# ECHELON Customer Support Alert

RE: RTR-10 CORE MODULE AND RTR-10 MOTHERBOARD CHANGES

DATE: JANUARY 1996

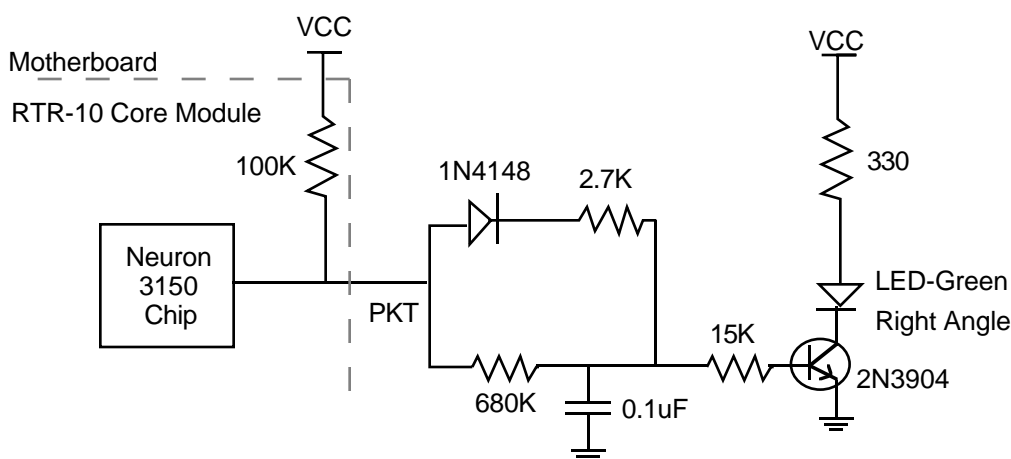
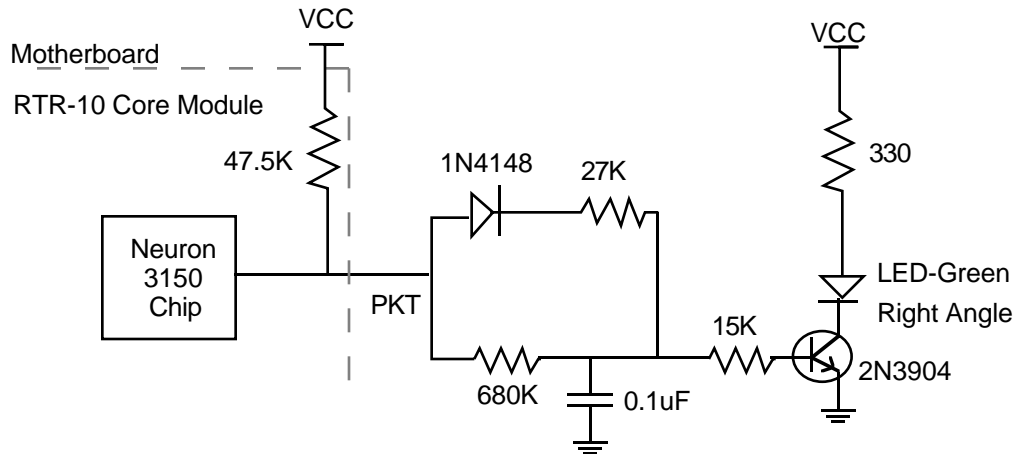
Below is the circuit as it exists using an RTR-10 module with engineering level 04 or below and the schematic from the *LONWORKS Router User's Guide*, Revision 3 or lower. (Note: the engineering level is incorporated in the manufacturing datecode as the last two digits. Thus, 9604F04 has an engineering level of 04.)

The two changes are: (1) on the motherboard schematic replace the 2.7K $\Omega$  resistor with a 27K $\Omega$  resistor (or greater); and (2) on the RTR-10 module replace the 100K $\Omega$  resistor with a 47.5K $\Omega$  resistor. When both changes are made, the new implementation will have the following circuitry:

New Echelon builds of the RTR-10 module (with change (2) above) will have engineering level 05.

Note: While the change to the RTR-10 module is sufficient to allow the proper interpretation of the transceiver ID with the old motherboard design, Echelon recommends that all new builds of RTR-10 motherboards incorporate the suggested resistor value change.
